January 19, 2011

**Subject: Modification of 100% Design Submittal  
Operable Unit 1  
Fletcher's Paint Works and Storage Facility Superfund Site  
CERCLA Docket No. 01-2001-0063  
Milford, New Hampshire**

ARCADIS U.S., Inc. (ARCADIS) has reviewed the Final Design Report and made the modifications necessary to adjust the depth of excavation cell V to conform to the correct seasonal low water table elevation. The following modifications to the Final Design Report are attached:

**PHASE 1 SOIL REMOVAL AREAS - ELM STREET AREA**

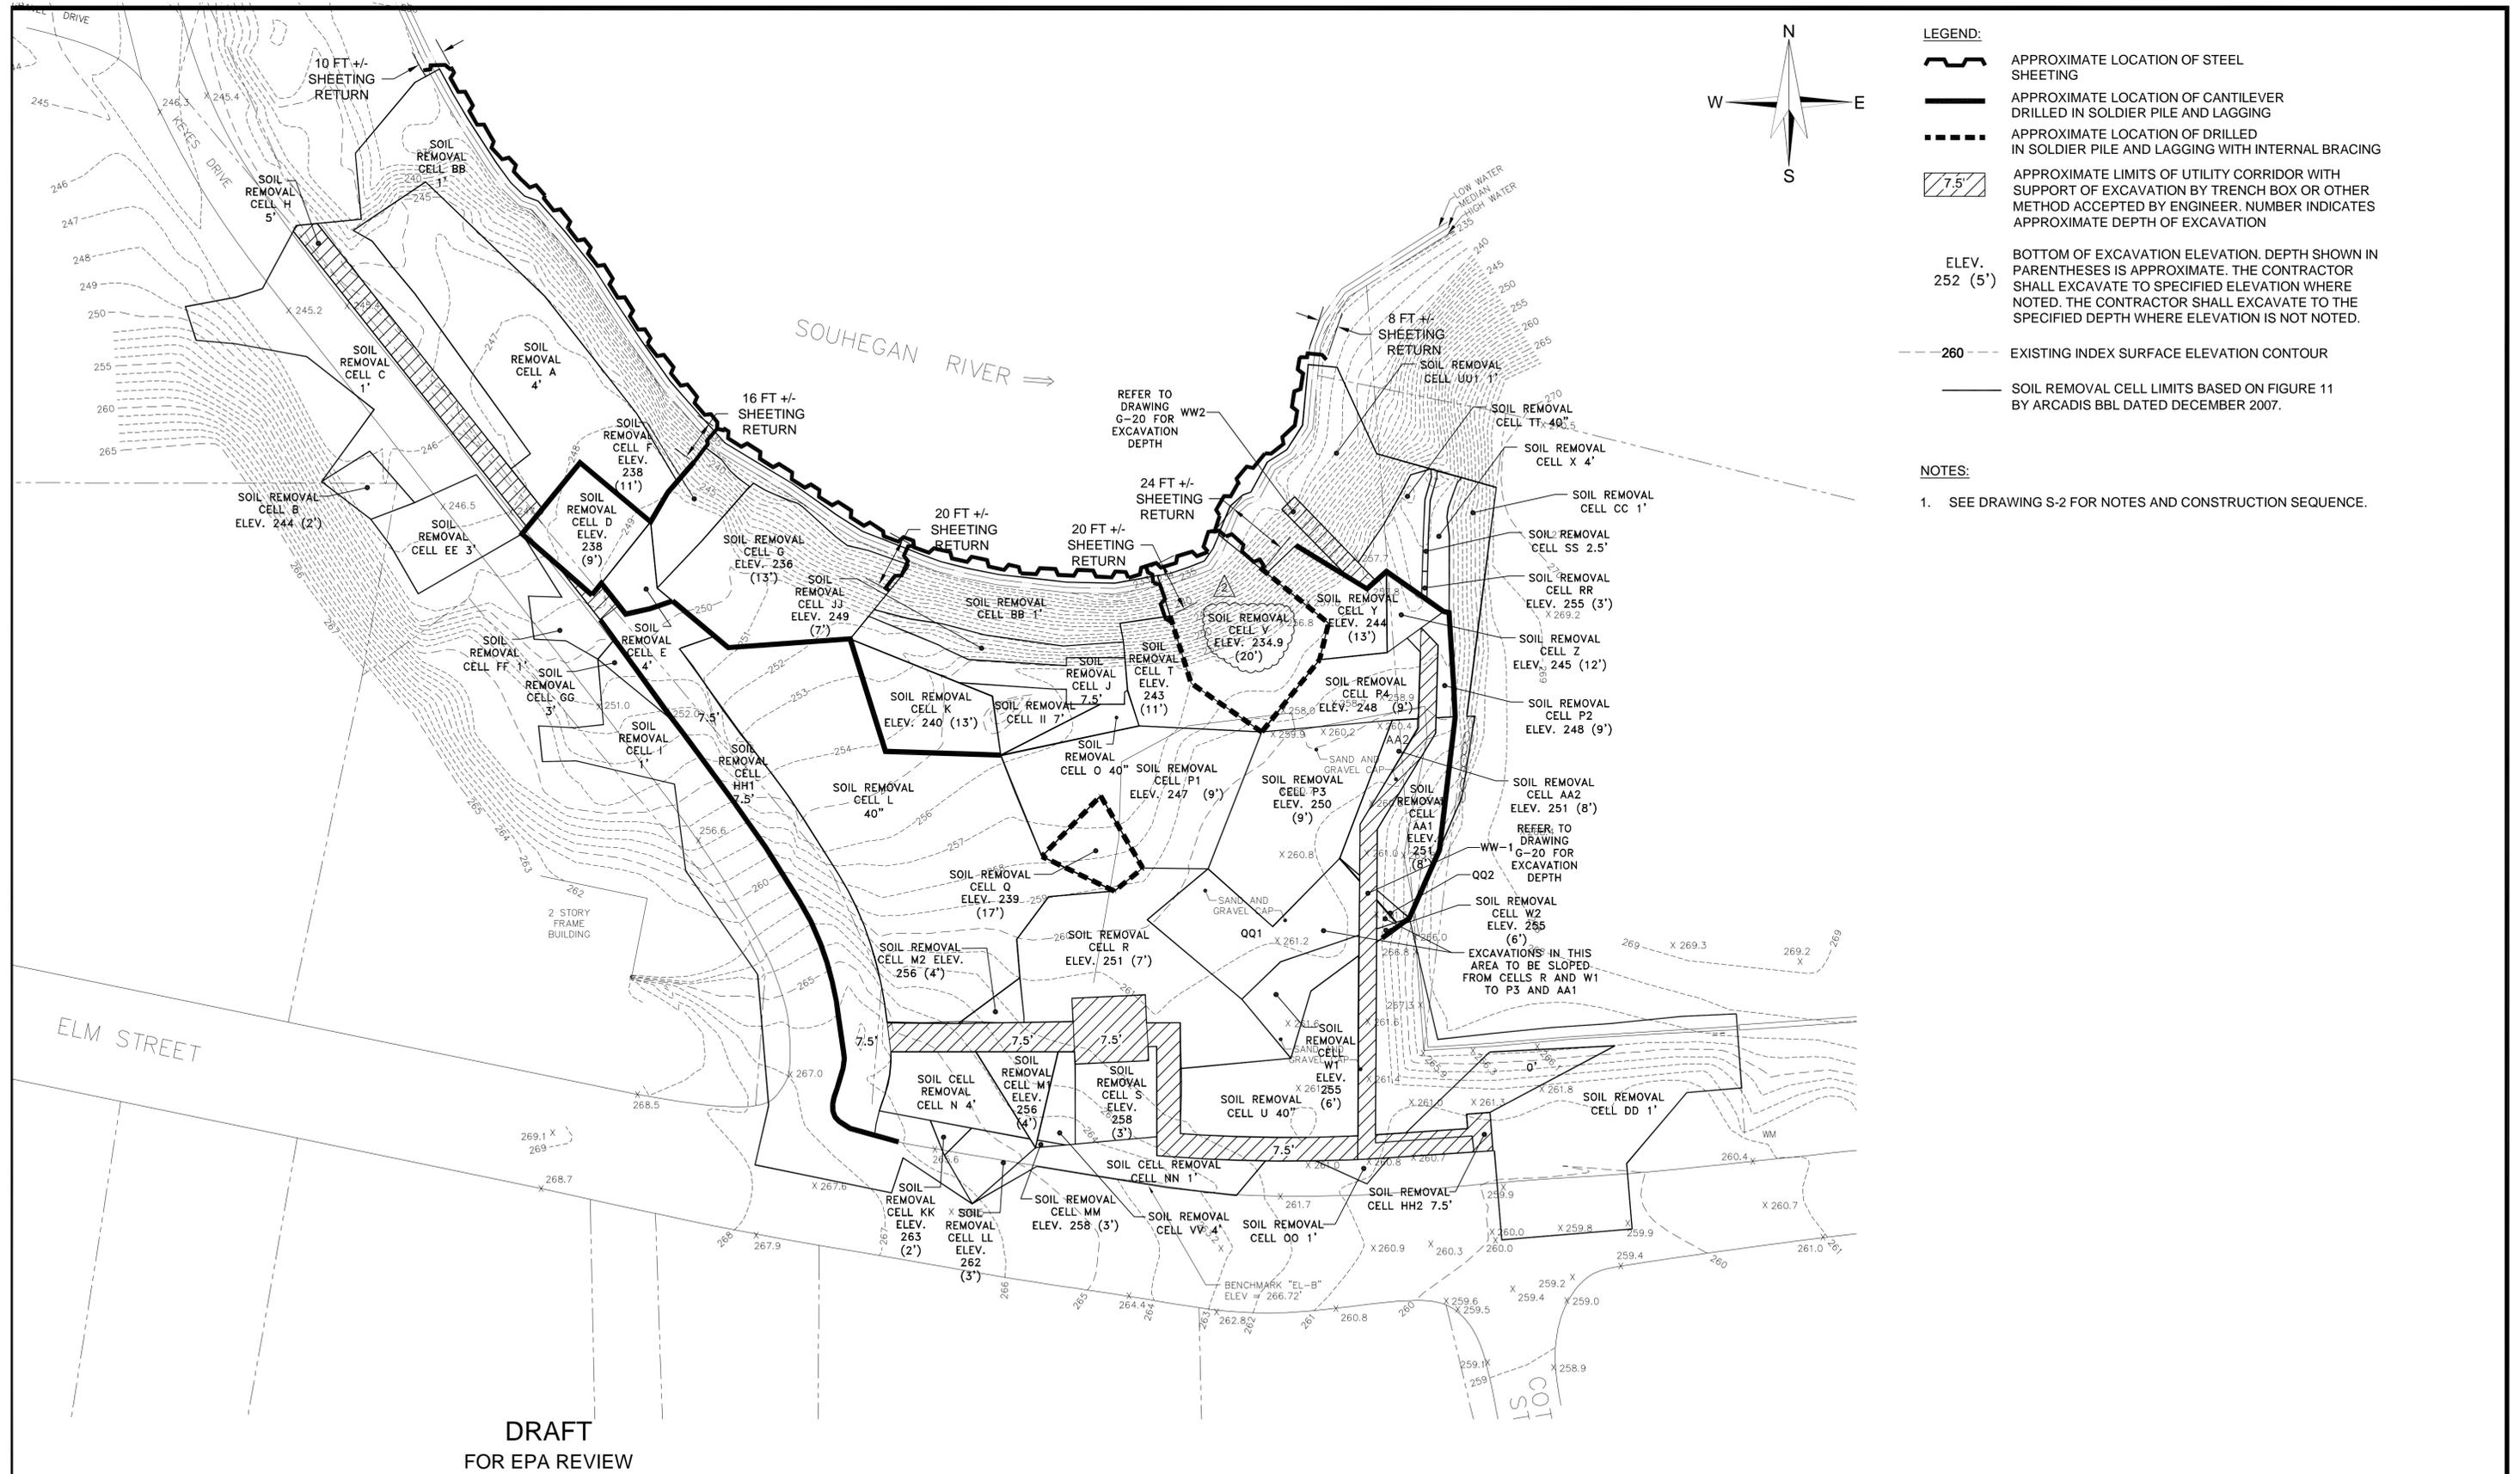
- Revision of Figure D-2 in Appendix D of Volume III of the Final Design Report to reflect a change to the base of excavation cell V based on the correct seasonal low water-table elevation, and related changes to the 1-foot excavation cell(s) to the north, northeast and northwest of cell V;

No.	Date	Revisions	Init
2	11/19/10	REVISED SEASONAL LOW WATER EDITS	DRS

GENERAL ELECTRIC COMPANY  
FLETCHER'S PAINT WORKS AND STORAGE FACILITY SUPERFUND SITE  
MILFORD, NEW HAMPSHIRE  
FINAL (100%) DESIGN REPORT  
**ELM STREET - SOIL REMOVAL LIMITS AND SUPPORT OF EXCAVATION SYSTEM LAYOUT**

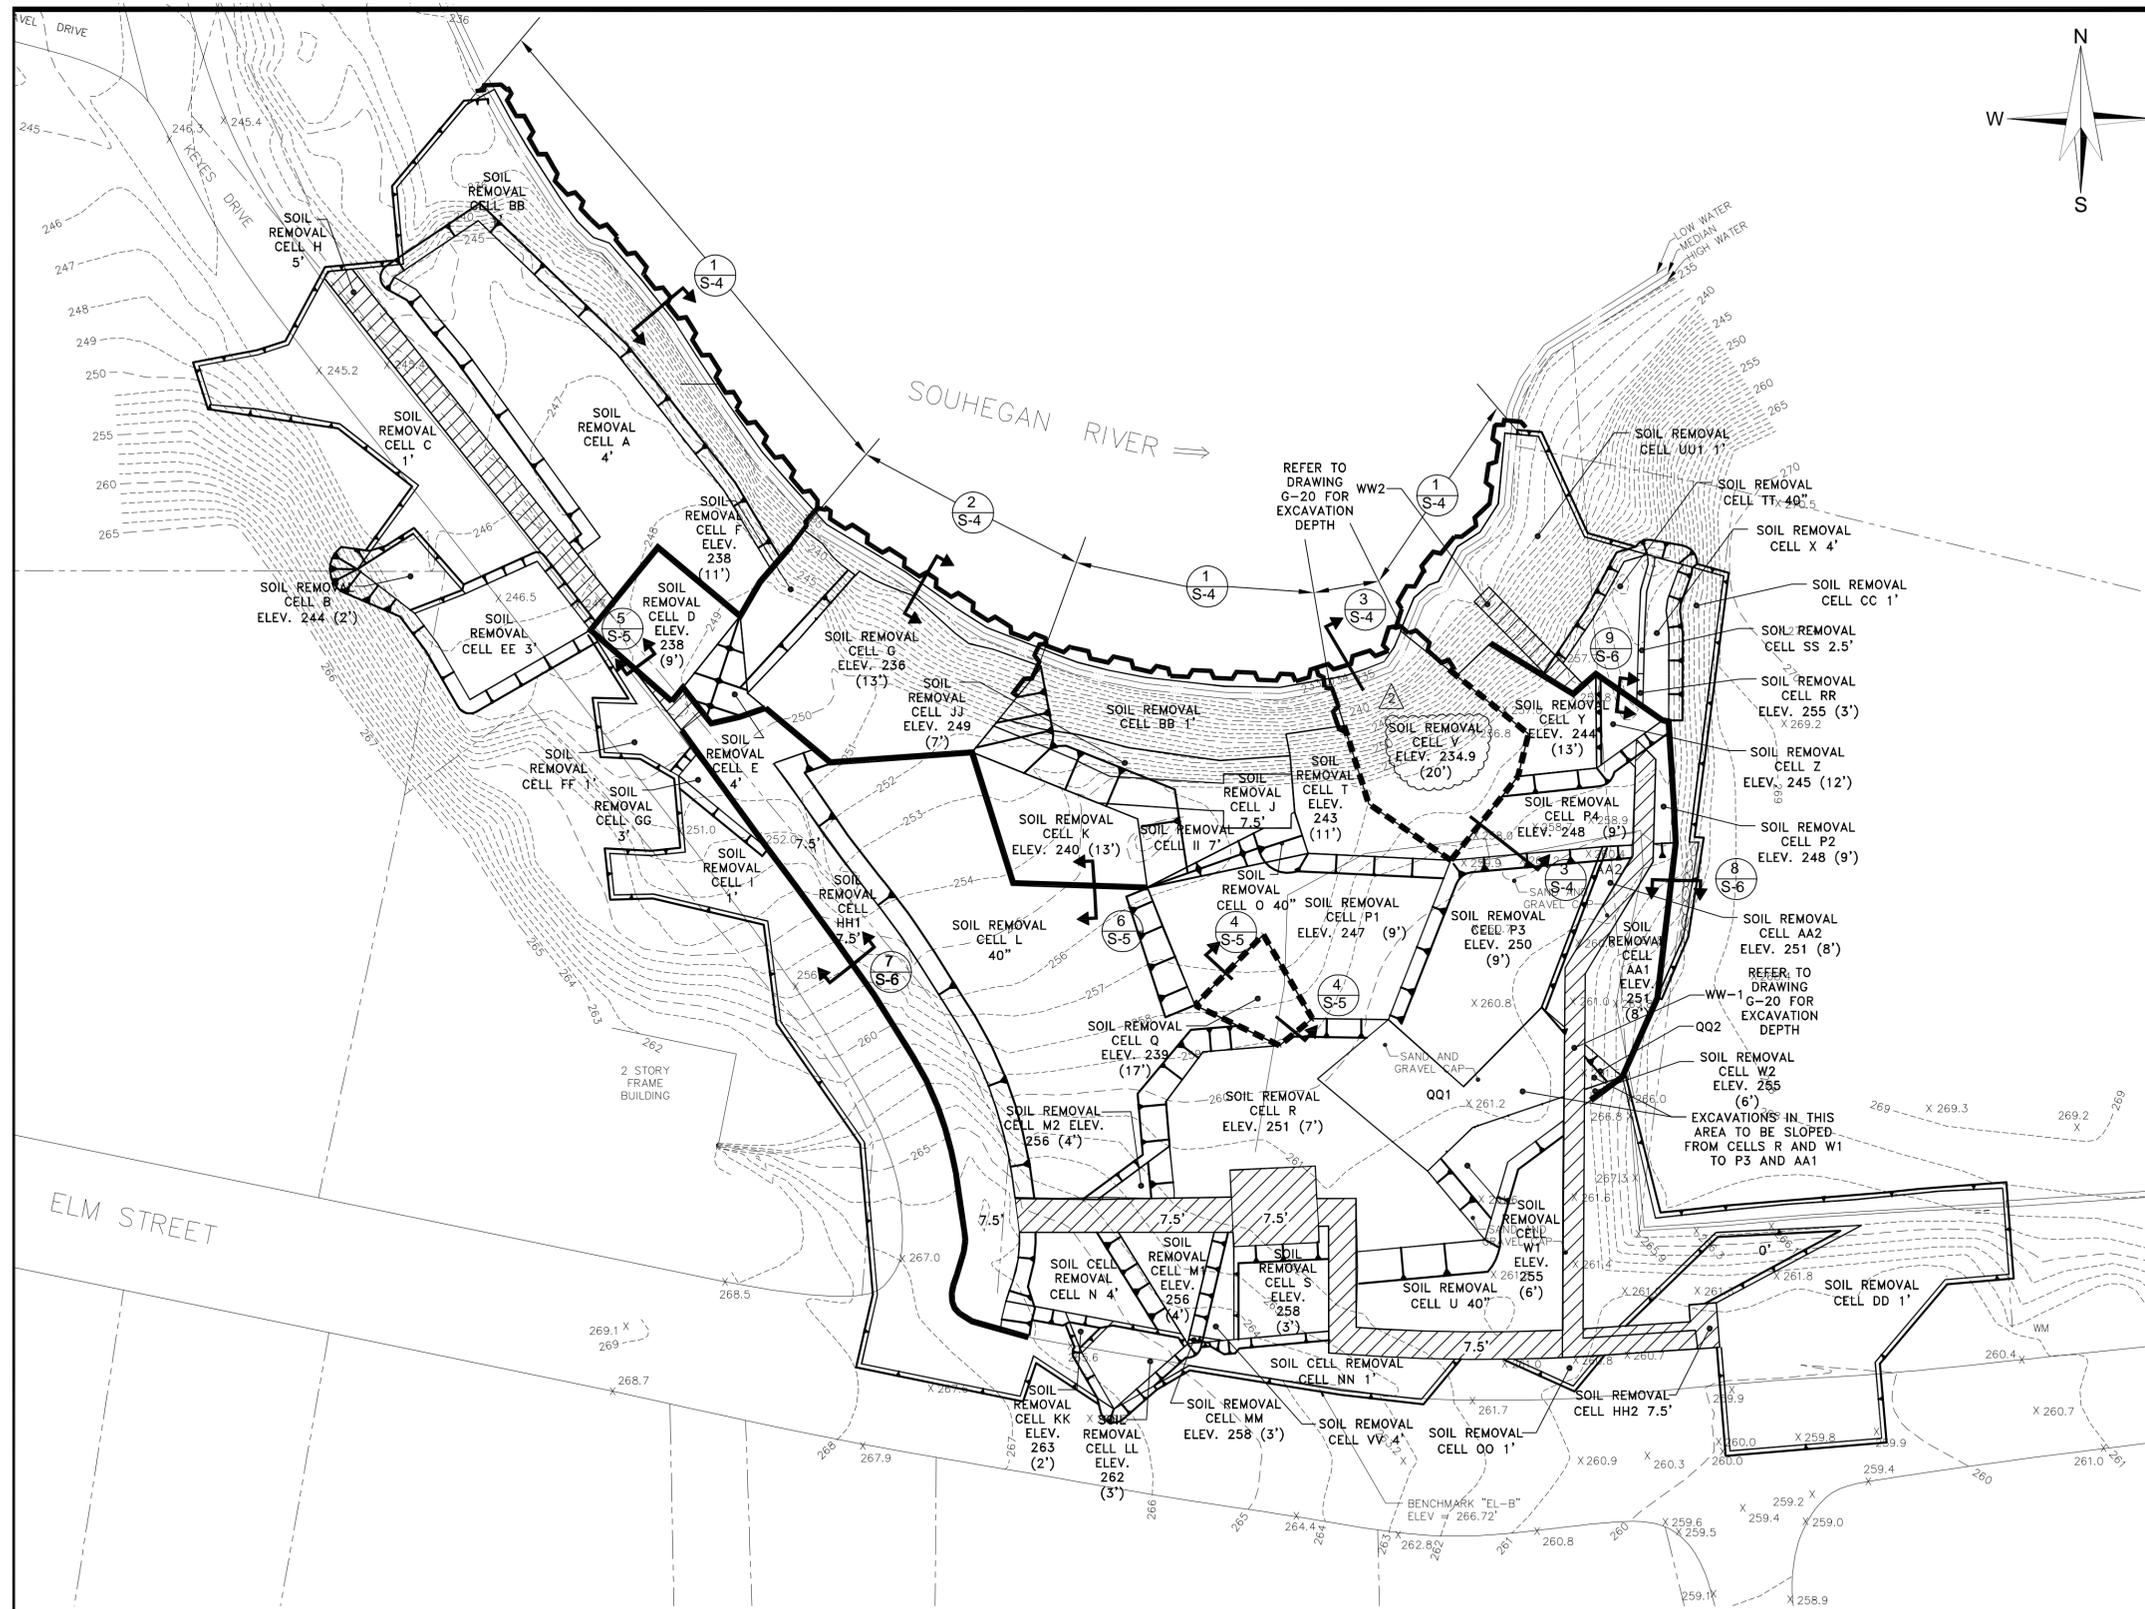
- Revision of Technical Drawings G-10, G-12, G-13, S-1 and S-2 in Appendix C of Volume II of the Final Design Report to reflect a change to the base of excavation cell V based on the correct seasonal low water-table elevation, and related changes to the 1-foot excavation cell(s) to the north, northeast and northwest of cell V;

- Revision of Technical Drawings S-3 and S-4 in Appendix C of Volume II of the Final Design Report to reflect modifications to the support of excavation for cell V;

No.	Date	Revisions	Init
2	11/19/10	REVISED SEASONAL LOW WATER	DRS
1	6/3/10	UPDATING NOTES	DRS

Client ARCADIS  
Project L&E FLETCHER  
Subject REVISED SEASONAL LOW H<sub>2</sub>O

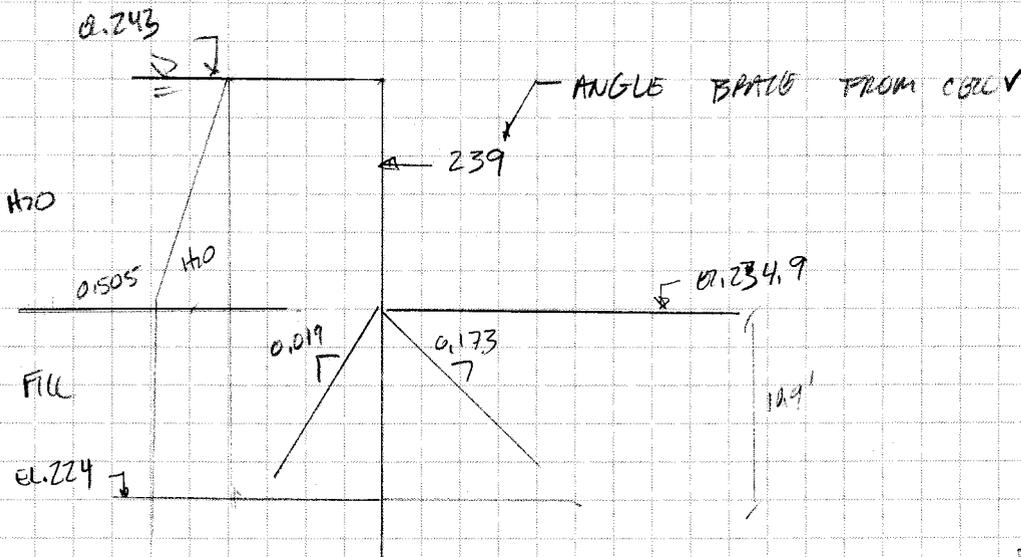
- 1) BASED ON THE RECENT BORINGS & REVISED SEASONAL LOW H<sub>2</sub>O TABLE REVIEW CALC'S & DRAWINGS.
- 2) REVISIONS EFFECT COUL V & DESIGN SECTIONS 2 & 5
- 3) BASED ON ATTACHED CALCULATIONS BRACE LOADS & MOMENTS GO DOWN
- 4) DRAWINGS HAVE BEEN REVISED TO REFLECT CHANGES, BRACING MEMBERS HAVE NOT BEEN CHANGED. REQUIRED SET EMBEDMENT HAS BEEN CHECKED & NO CHANGES ARE REQUIRED.

Subject RAISED DESIGN H<sub>2</sub>O LEVEL

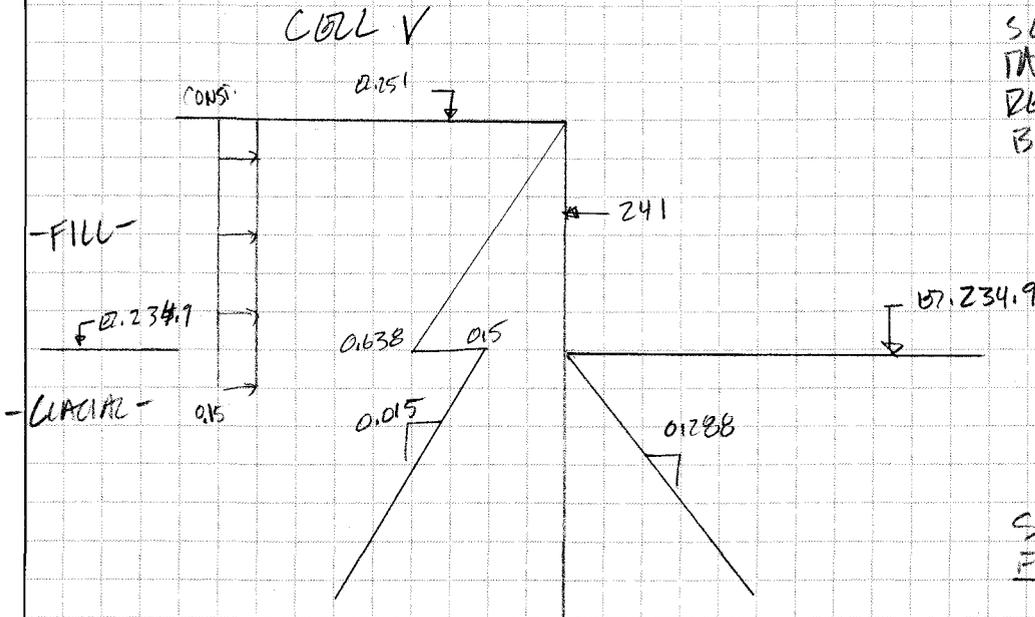
BASE LOAD = 6.9 USE 7 K/CF FOR DESIGN.
